## Access Compliance Report Public Rights-of-Way (Curb Ramps)

Intersection ID: 19048 Main Street: CORY-BRET\_LN Cross Street: SHOPTON\_RD\_WEST Location: NE

ADA ID: BBB0754C5E1B Ramp Type: PerpDiag Initial Pass/Fail: Fail Overall Compliance: No Severity Score: 13.75

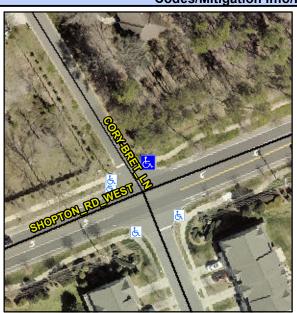
R304.2.2, R304.5.3

Remove & Replace Curb Ramp With
Two New Directional Ramps or
Equivalent.
